Addendum No.: 2

Bid#: 23-52-2

Project Name: S. Military Rd US 190 & Rue Esplanade Water Main

SHEET NO.
2c - REVISED
(ADD #2)

UNDER PAVEMENT TRENCH DETAIL
(NOT TO SCALE)

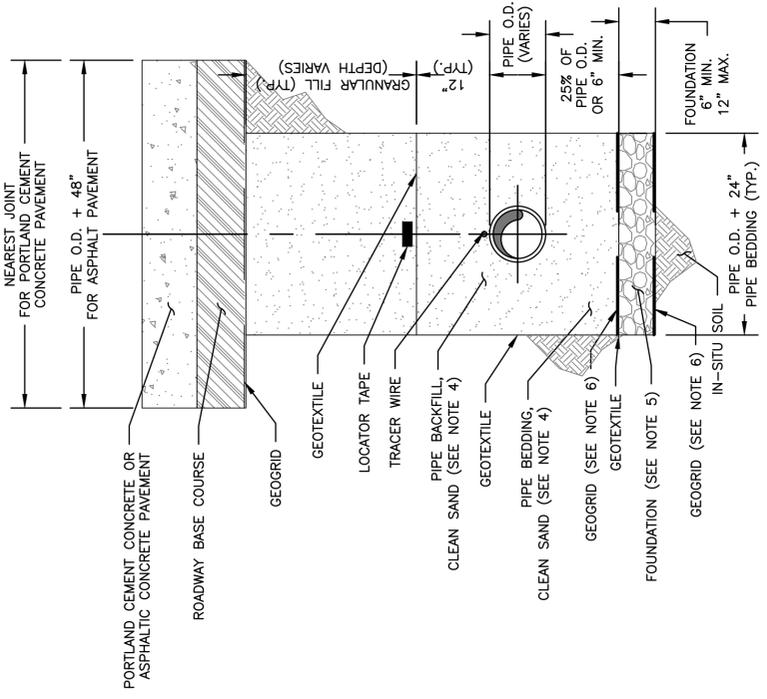
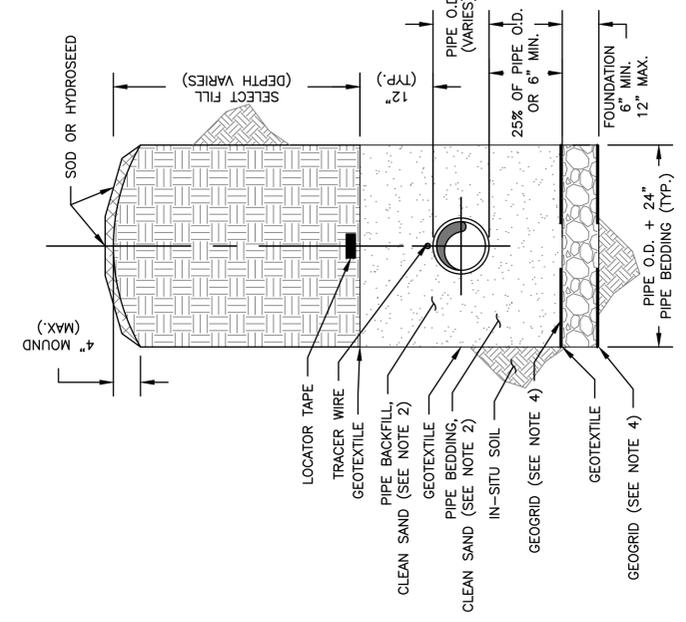
Detail and Notes for Trench Detail Outside of Pavement on Sheet 2c have been revised and provided on Sheet 2c (ADD #2) to allow for compaction of backfill by flooding. Compaction of backfill under pavement will be by mechanical means. Details and notes for both trenching details have been revised.

- BEDDING AND BACKFILL MATERIALS FOR WATER LINES SHALL BE A CLEAN SAND COMPLYING WITH ASHTO GROUP CLASSIFICATION A-3. ALL BEDDING AND BACKFILL MATERIALS SHALL BE PLACED IN LIFTS NOT EXCEEDING A THICKNESS OF EIGHT INCHES (8") PER LIFT AND THEN COMPACTED BY MECHANICAL MEANS. SAND BEDDING AND BACKFILL MATERIALS SHALL HAVE MINIMUM COMPACTION OF 95% OF THE MAXIMUM DRY UNIT WEIGHT AS DETERMINED BY ASTM D698.

TRENCH DETAIL OUTSIDE OF PAVEMENT
(NOT TO SCALE)

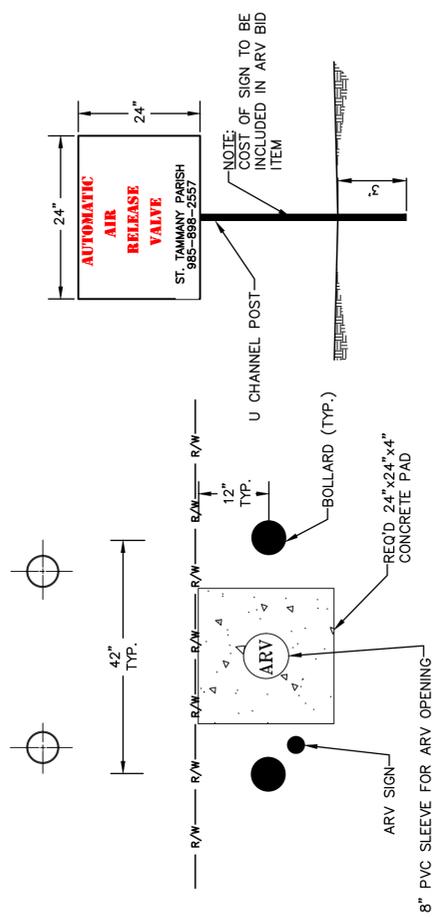
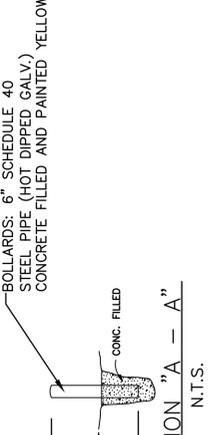
Please clarify Open Cut details concerning lifts and density testing.

- BEDDING AND BACKFILL MATERIALS FOR WATER LINES SHALL BE A CLEAN SAND COMPLYING WITH ASHTO GROUP CLASSIFICATION A-3. BEDDING AND BACKFILL MATERIAL SHALL HAVE MINIMUM COMPACTION OF 95% OF THE MAXIMUM DRY UNIT WEIGHT AS DETERMINED BY ASTM D698. SAND BACKFILL MATERIALS CAN BE COMPACTED BY FLOODING PRIOR TO TESTING. OTHERWISE, BACKFILL SHALL BE PLACED IN 8" LIFTS AND COMPACTED BY MECHANICAL MEANS TO 95% PER ASTM D698.
